BAR 16-03-03
513 14th Street NW
Tax Parcel 050087000
Lane Bonner, Owner/Wassenaar & Winkler Architects, Gregory Winkler, Applicant
Two Story/Attic Additions – Final Details – Landscape Plan and Railings

**CITY OF CHARLOTTESVILLE
BOARD OF ARCHITECTURAL REVIEW
STAFF REPORT
November 15, 2016**

BAR 16-03-03

513 14th Street NW

RAIL DETAIL - ELEVATION

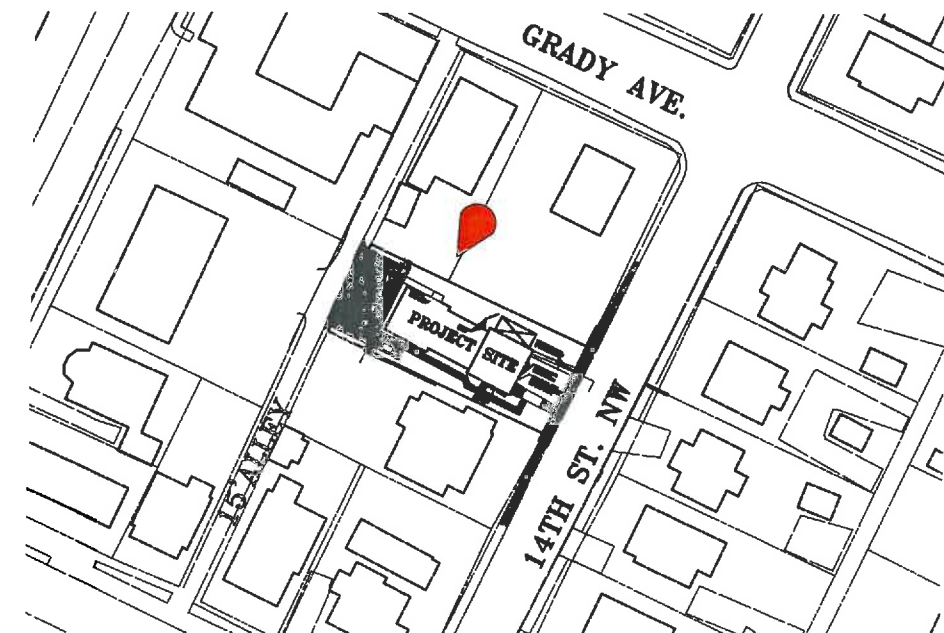
The proposed railing along the walkway and stairs on the north side matches the balcony railings on the rear of the addition. It is guardrail height, 3'-6", constructed of wood in a Chippendale design and is painted to match the building trim.

In August staff received four positive votes regarding the railing; no concerns were expressed at that time. The railing is appropriate in staff opinion, although a dark paint color such as black or Charleston Green would also be appropriate.

1 PLANTING PLAN
scale: 1"=10'-0"

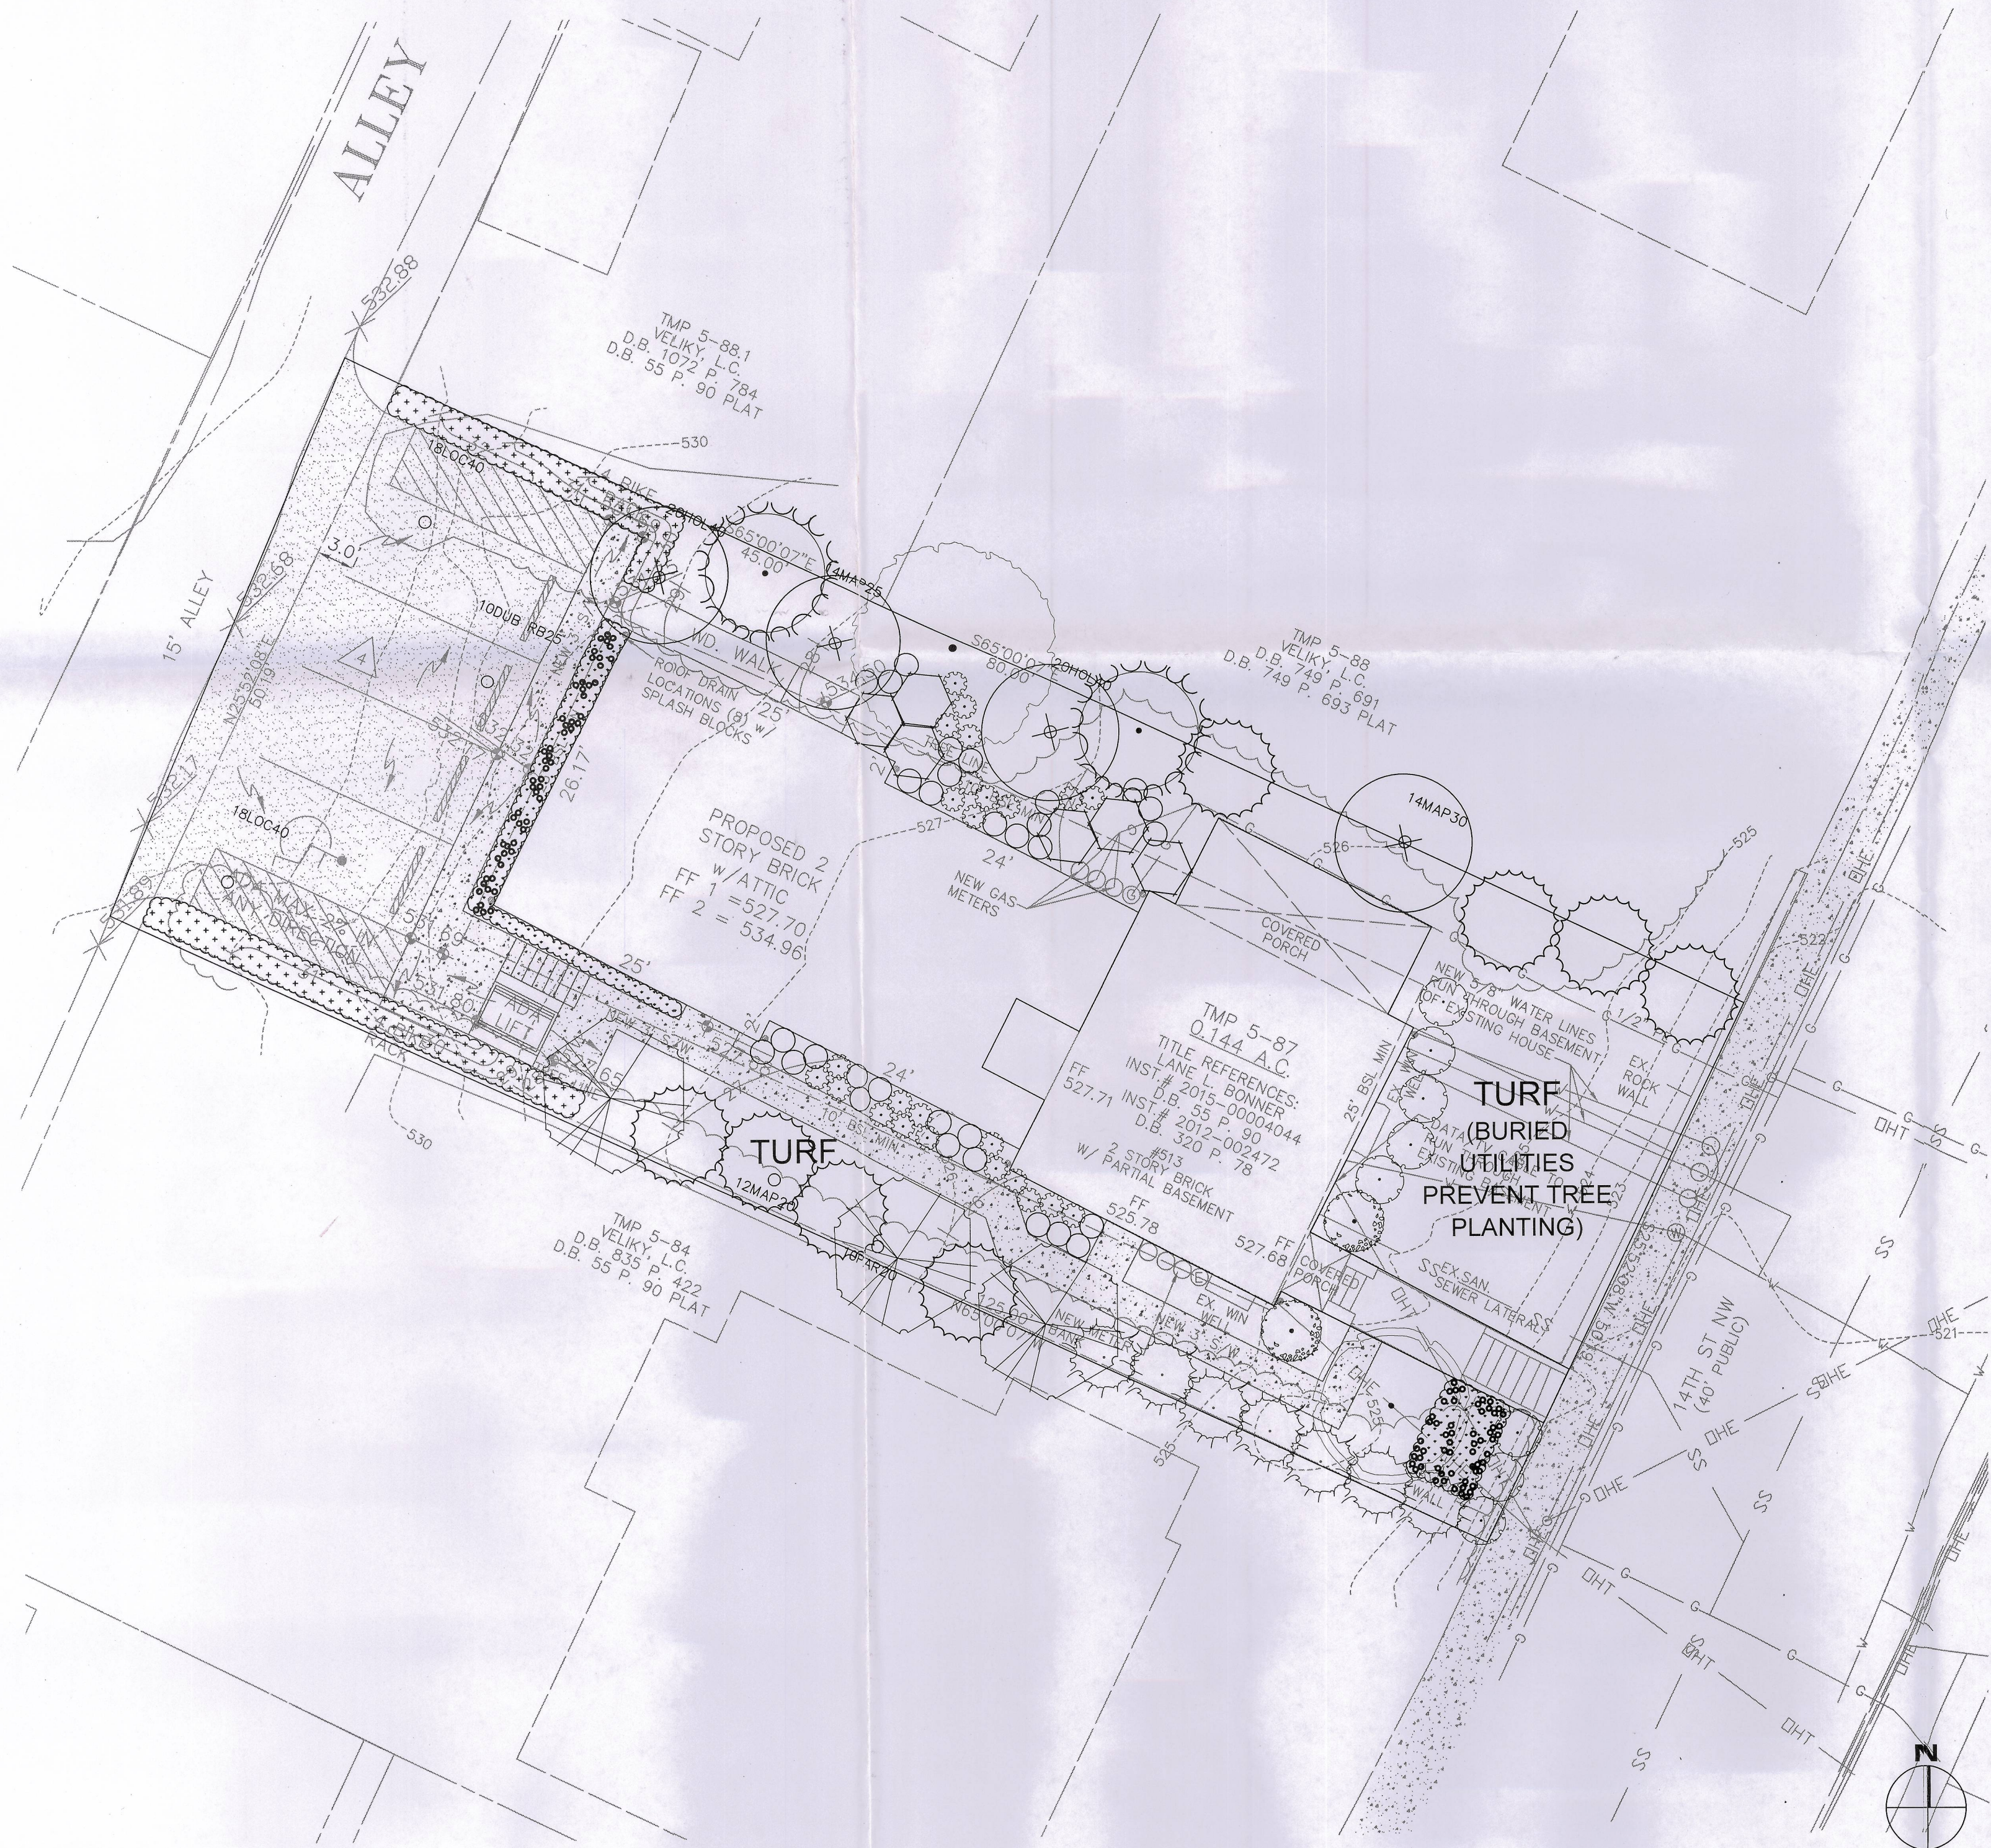
Five responses were received at that time regarding the landscape plan. One member requested a professionally-designed, high-quality plan that complements the professionally designed, high quality architectural design. It was suggested that the applicant consult with professional landscape architecture firm instead of relying on a landscaping contractor. Three others deferred to that opinion. The fifth member who responded said the foundation plantings and lift screen were generally OK, but they wanted street trees that were not columnar, that would shade the sidewalk.

The applicant has engaged Land Planning and Design to prepare the plan. They note that utility lines preclude the street trees previously proposed.

The current plan proposes to remove three trees from the rear parking area, and two trees from the south side yard. Four existing trees in the north side yard will be maintained. (see landscape plan dated July 12, 2016 with existing trees circled).

The proposed plan adds two shade trees: a River Birch near the front, and a Tulip Polar on the north side yard. In addition, the plan adds 3 Sweetbay Magnolias on the south side yard, and evergreen trees and shrubs.

Zoning requires at least 2 street trees; the River Birch would count as one. Public Works requires at least 5 feet separation between a City maintained utility line (including a gas lateral) if a root barrier is installed; 10 feet minimum without a root barrier.

Staff recommends that the applicant figure out a way to add a second street tree.

Having considered the standards set forth within the City Code, including City Design Guidelines for New Construction and Additions and for Site Design, Mr. Balut moved to find that the proposed landscape plan and railings satisfy the BAR's criteria and guidelines and is compatible with this property and other properties in the Rugby Road-University Circle-Venable Neighborhood ADC district, and that the BAR approves the application with the following modification : that a second street tree is added to the front of the property, with the stipulation that the street tree be an appropriate shade tree for the street. Ms Knott seconded. The motion passed (7-0).
